Beaver Valley Power Station, Unit No. 1
Proposed Technical Specification Change No. 225

Beaver Valley Power Station, Unit No. 2
Proposed Technical Specification Change No. 96

Beaver Valley Power Station, Unit Nos. 1 and 2 Proposed Technical Specification Change Nos. 225 and 96 REVISION OF SURVEILLANCE REQUIREMENT 4.6.2.2.d AND ASSOCIATED BASES

[1RS-P-1A]
 MOP CURVE

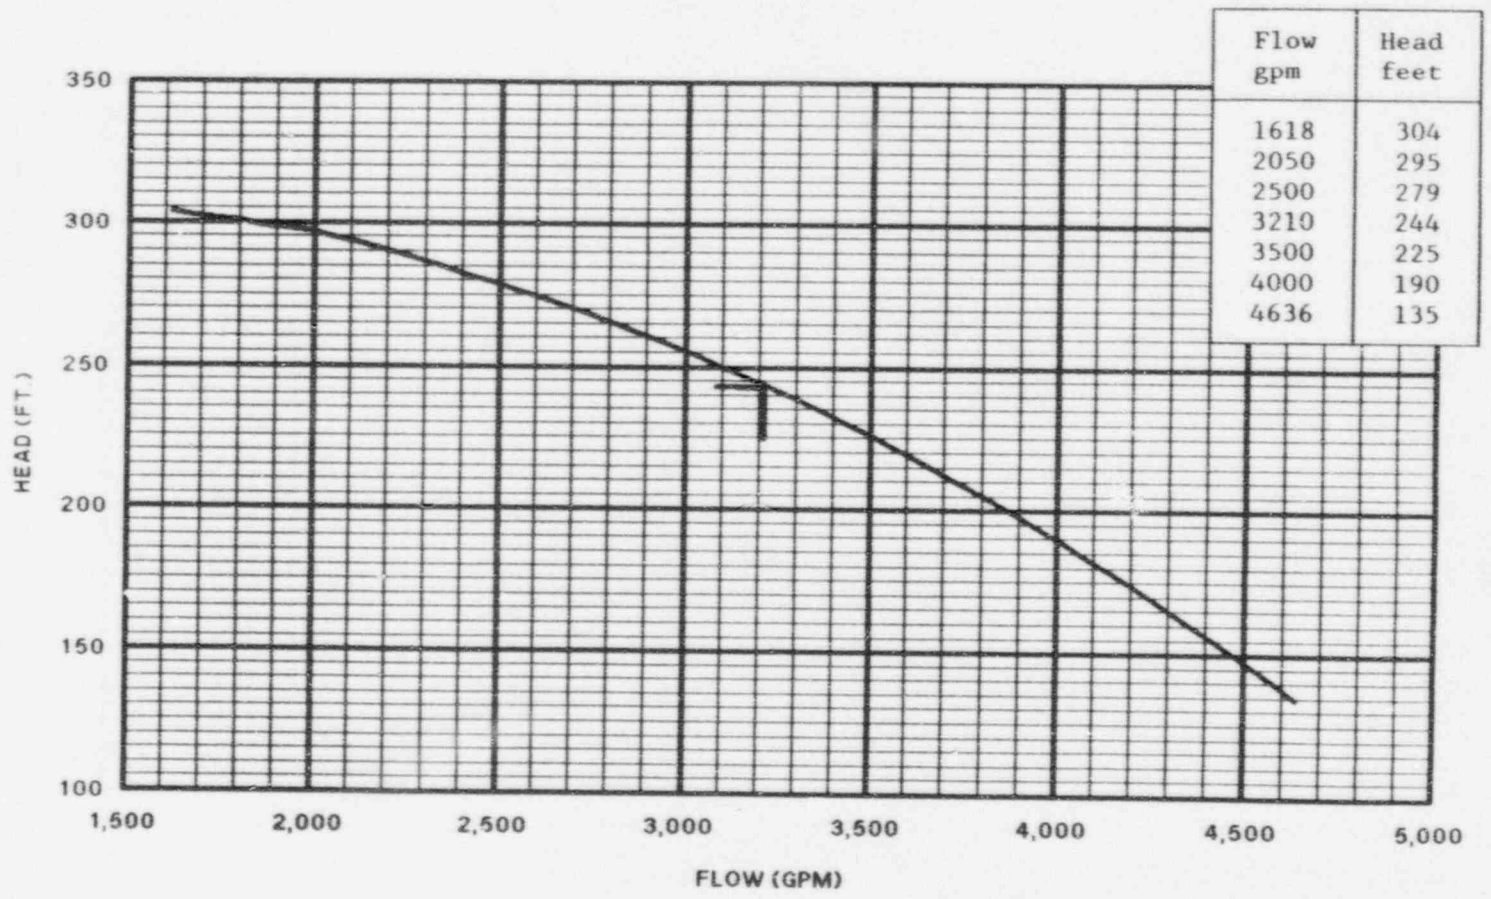
Proposed Revisions To The Inservice Testing Program
For Pumps And Valves

Pump Name: 1A Inside Recirculation Spray Pump

Pump Number: [1RS-P-1A]

THE MOP VALUE IS 244 FT AT 3210 GPM,
 EM 106323

[1RS-P-1B] MOP CURVE

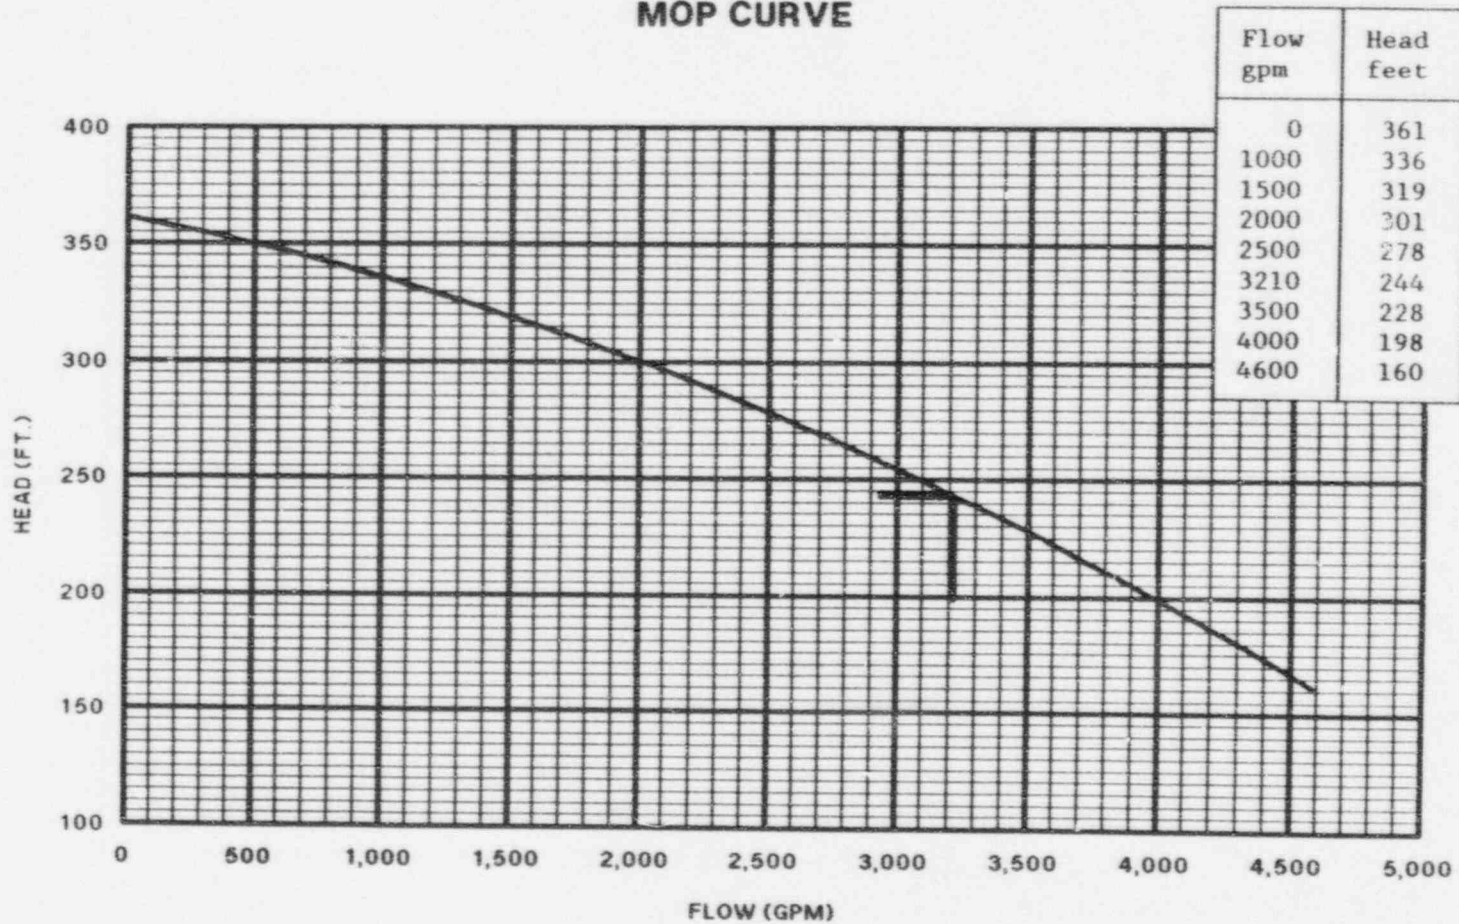
Pump Name: 1B Inside Recirculation Spray Pump

Pump Number: [1RS-P-1B]

THE MOP VALUE IS 244 FT AT 3210 GPM,
EM 110602.

**[1RS-P-2A]
MOP CURVE**

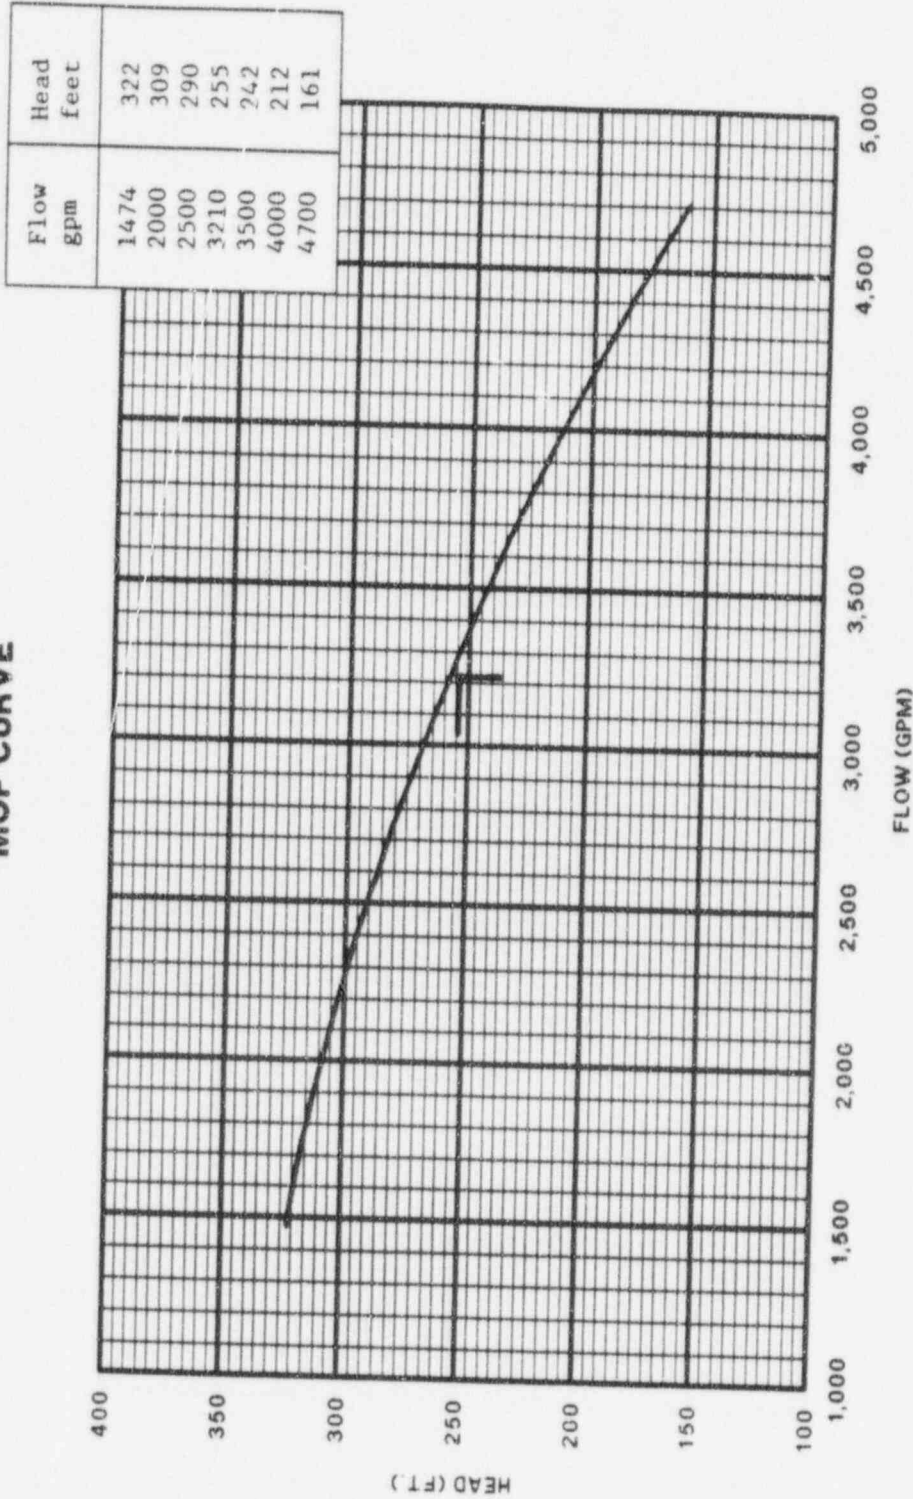
Pump Name: 2A Outside Recirculation Spray Pump

Pump Number: [1RS-P-2A]

THE MOP VALUE IS 255 FT AT 3210 GPM,
EM 106323

[1RS-P-2B] MOP CURVE

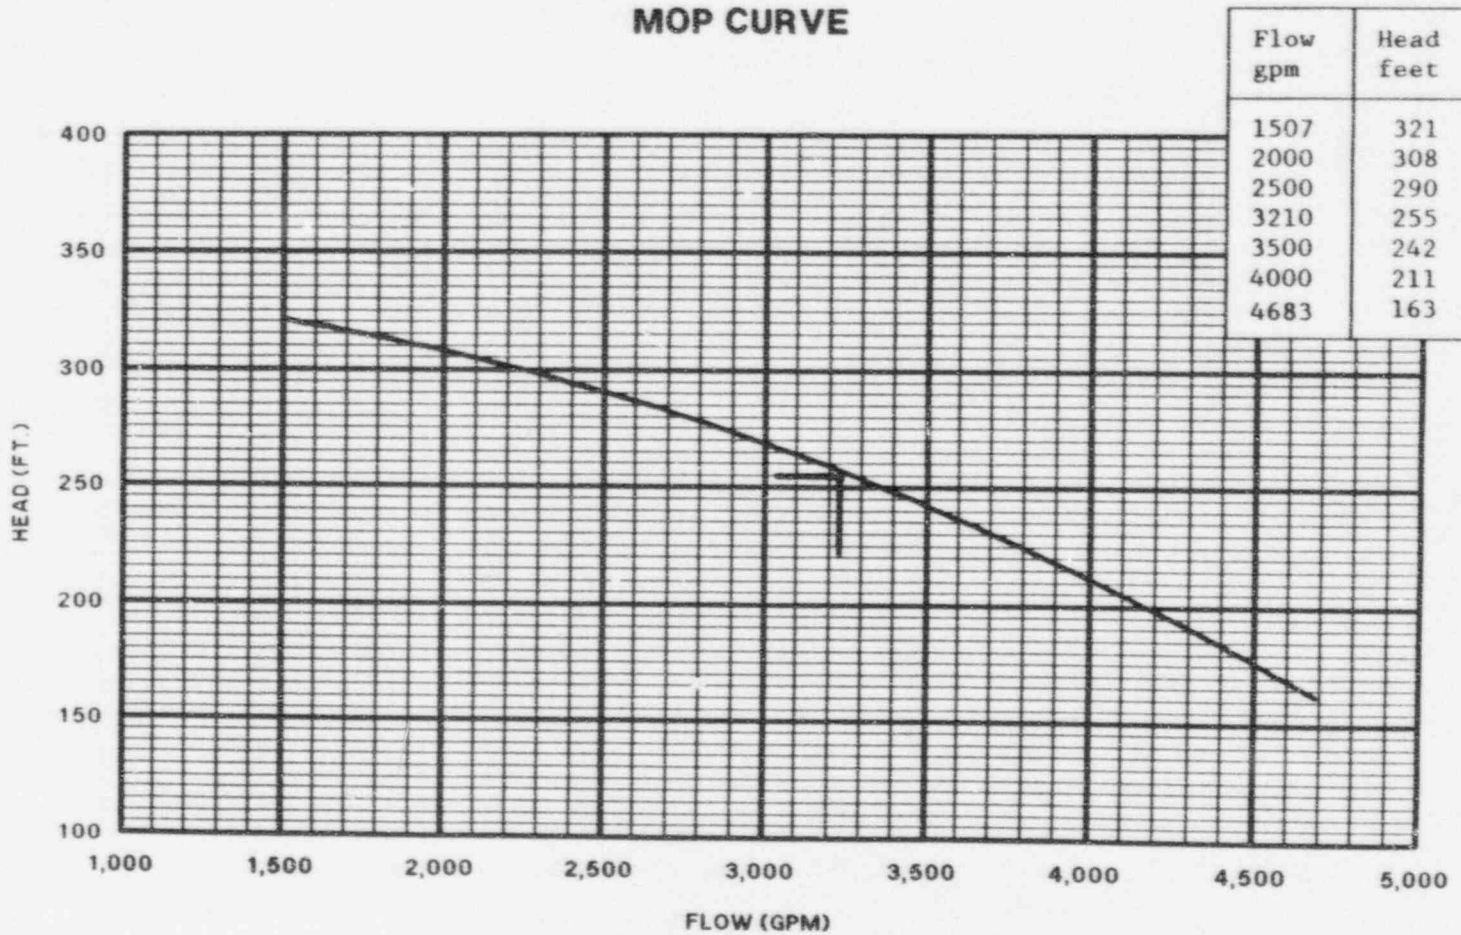
Pump Name: 2B Outside Recirculation Spray Pump

Pump Number: [1RS-P-2B]

THE MOP VALUE IS 255 FT AT 3210 GPM,
PER EM 110602.
